Supplemental Environmental Impact Report

Proposed Modifications to the Pure Water Monterey

Groundwater Replenishment Project

April 2020

Figure
2-5A
NEW

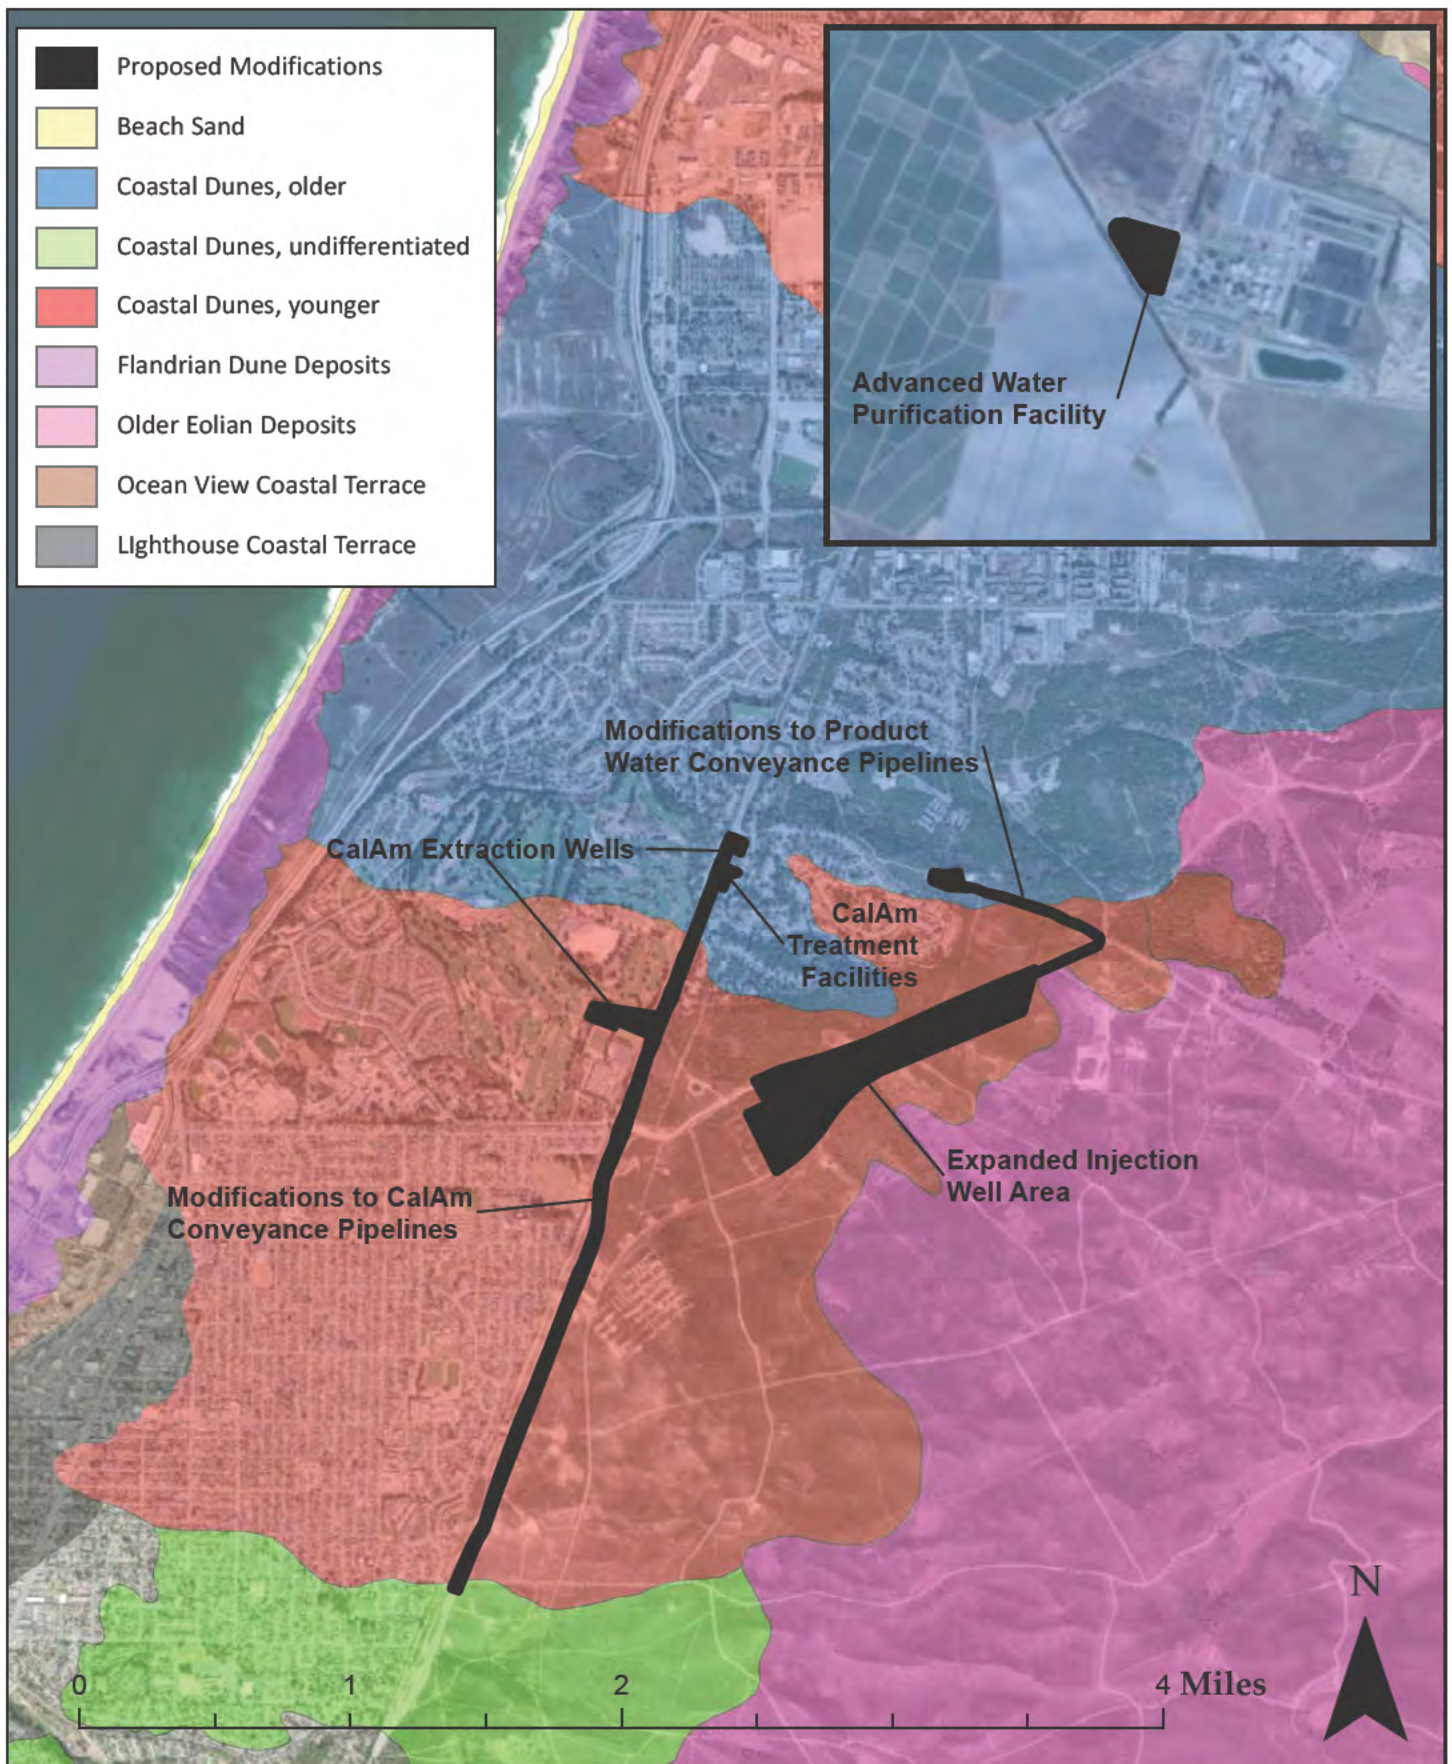
Chapter 2 (Figure 2-2) includes reference to a shared potable water pipeline on General Jim Moore Blvd but it does not describe that this pipe is owned 100% by MCWD and it does not describe the manner in which use of the MCWD-owned pipeline is shared among agencies.

“The Blackhorse Reservoir and the conveyance pipeline from this reservoir site to the injection wellfield are owned by MCWD and jointly used for the approved PWM/GWR Project. See Figure 2-5A at the end of this chapter for a detailed depiction of the pipeline connection to the lateral pipeline feeding the Blackhorse Reservoir. The existing product water conveyance pipeline from the Product Water Pump Station to the Blackhorse Reservoir is sufficiently sized to handle

Figure
4.8-2 REV

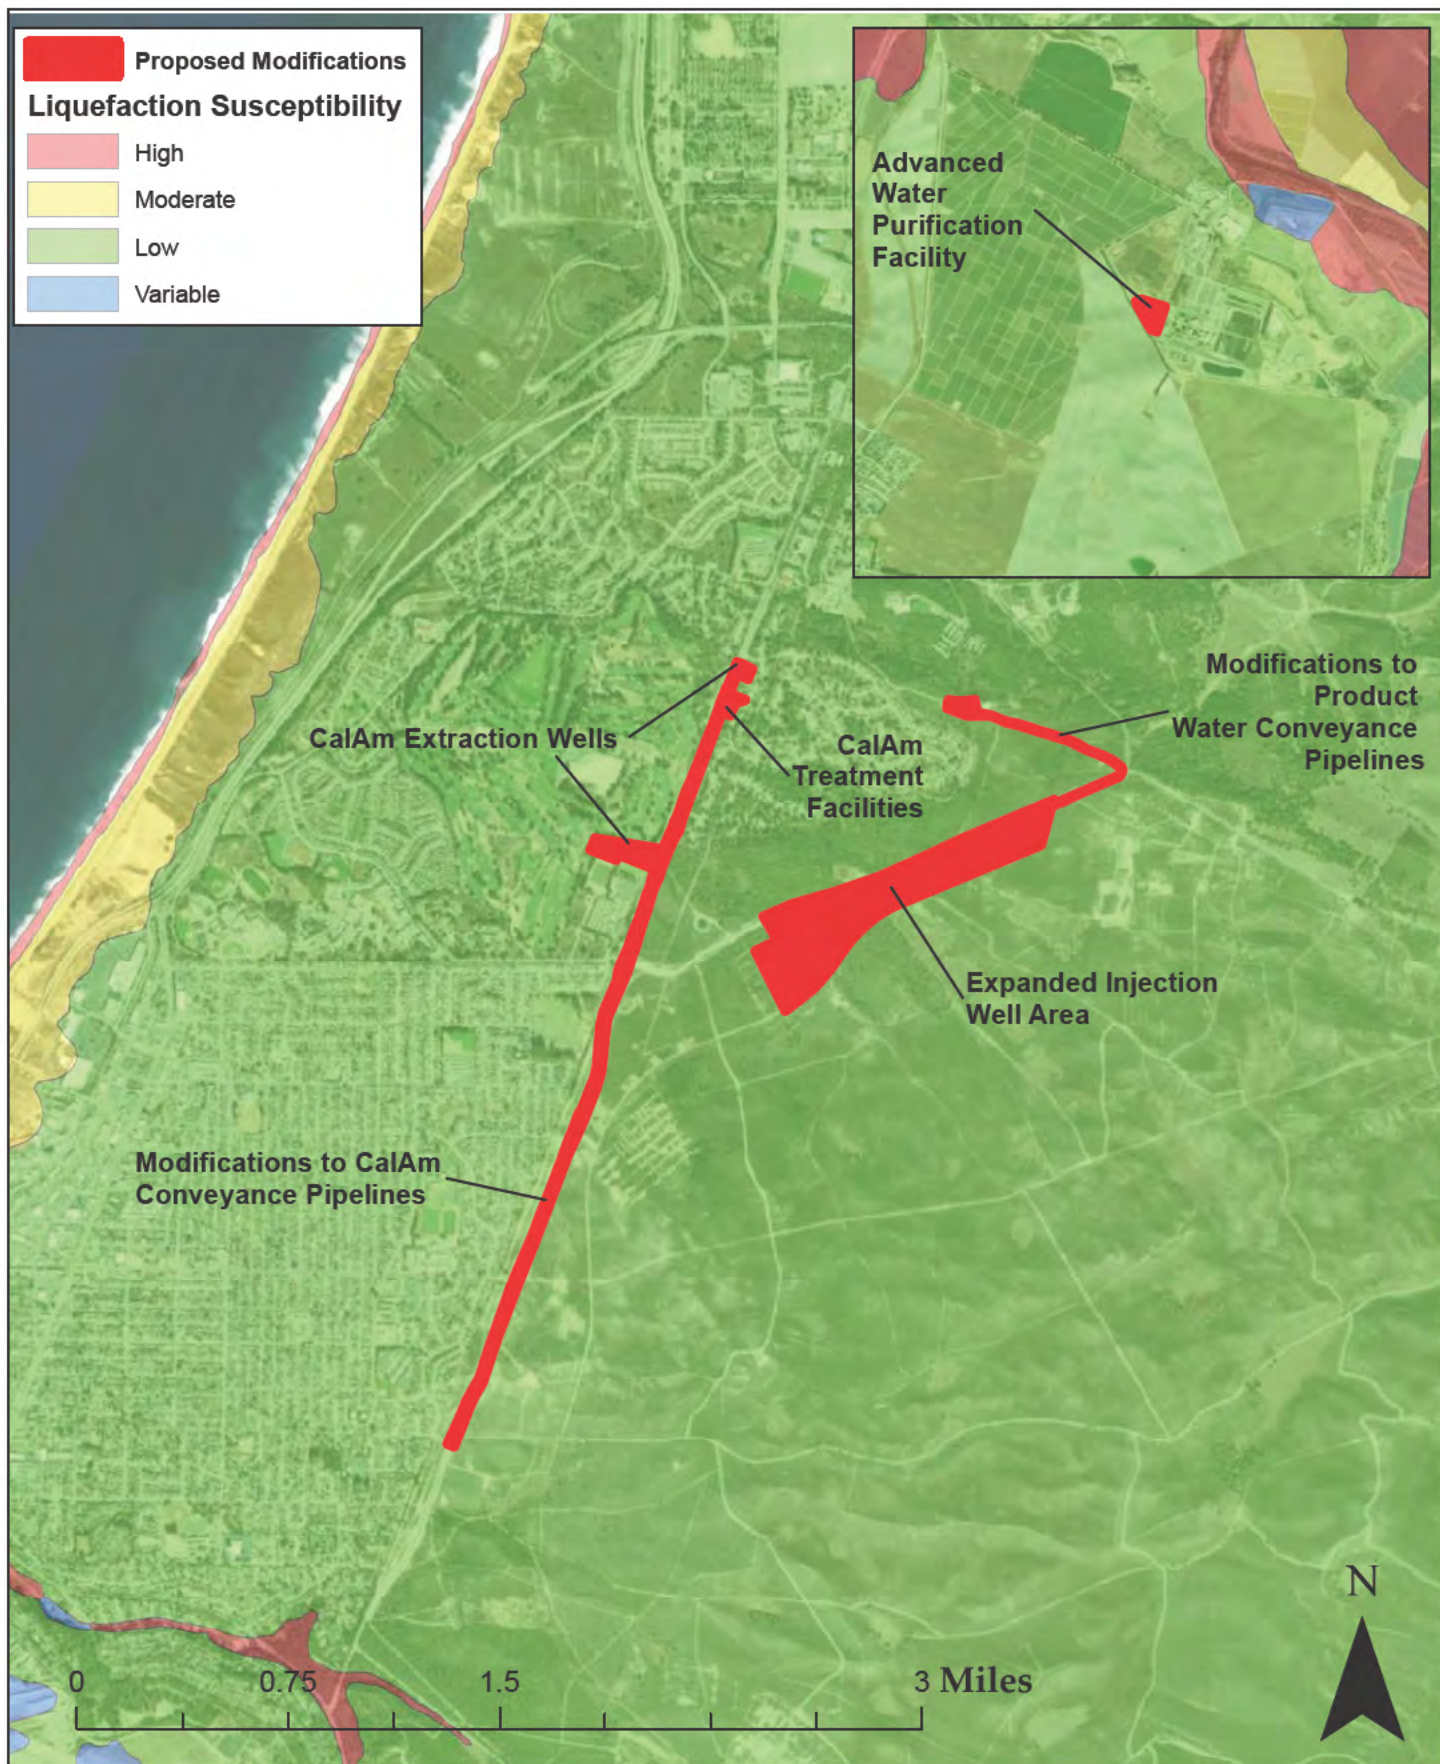
First, the figures and maps do not label any of the PWM Expansion Project’s components other than the Advanced Water Purification Facility. (Draft SEIR, pp. 4.8-3 to 4.8-5, 4.8-7, Figures 4.8-1 to 4.8-4.) Instead, all features are portrayed as unlabeled blobs, indecipherable to persons not already familiar with the project. (*Ibid.*) To properly inform the public and decisionmakers the figures must be revised to depict all other expansion components, including but not limited to, the product water conveyance pipeline, injection well facilities, and the Cal-Am distribution system improvements.

Second, the Draft SEIR describes the Advanced Water Purification Facility and Injection Well Facilities, but lacks important information about the soil characteristics where they are sited. (Draft SEIR, p. 4.8-6.) Figure 4.8-4 shows that these components must be located within a moderate soil erosion hazard area. As written, the information may be interpreted as confusing and conflicting. The SEIR must be revised so that these component descriptions are consistent with Figure 4.8-4.

- VV-44** See responses to comments VV-45 through VV-48 below.
- VV-45** See **Chapter 5, Changes to the Draft SEIR**, detailing changes to pages 4.8-3 to 4.8-5 and 4.8-7; **Figures 4.8-1 to 4.8-4** have been revised to label the individual components of the PWM Expansion.

Page 4.8-4 In response to comment VV-45, **Figure 4.8-2** has been amended to include labels of individual PWM Expansion components and is included at the end of this chapter.

Figure
4.17-1
NEW

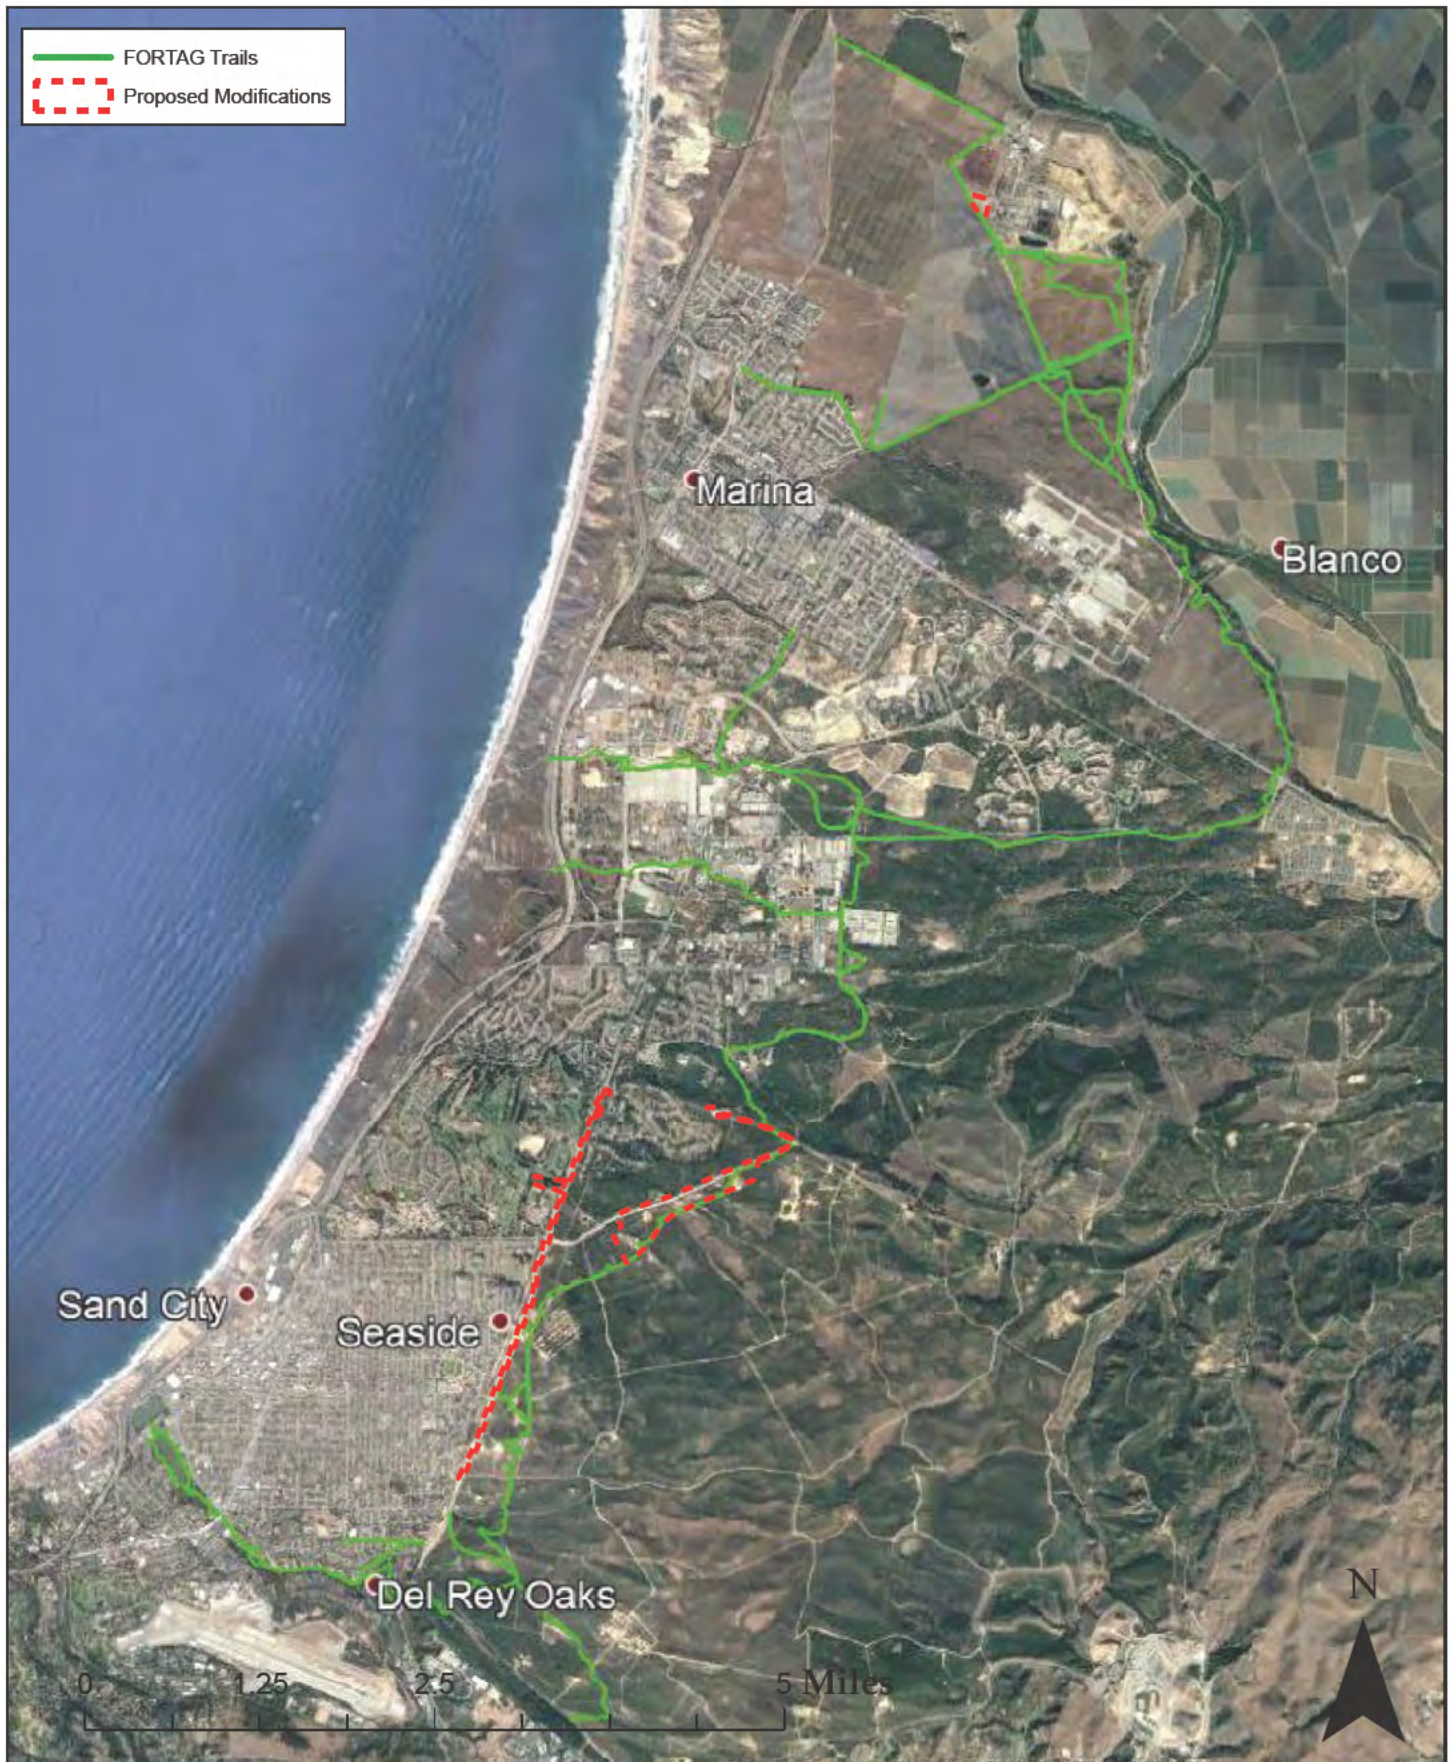
- Please include the proposed FORTAG trail alignment in Section 4.17, Traffic and Circulation.
- Allow the FORTAG trail alignment through the proposed expanded injection well area, as shown in Figure 2-3.
- The FORTAG trail could serve wildland fire vehicles through the project site.

Page 4.17-4 **Figure 4.17-1 FORTAG Trail Segments NEW** is added (shown at the end of this Chapter of the Final SEIR):

Page 4.17-5 **Figure 4.17-2 FORTAG Regional Map NEW** is added (shown at the end of this Chapter of the Final SEIR):
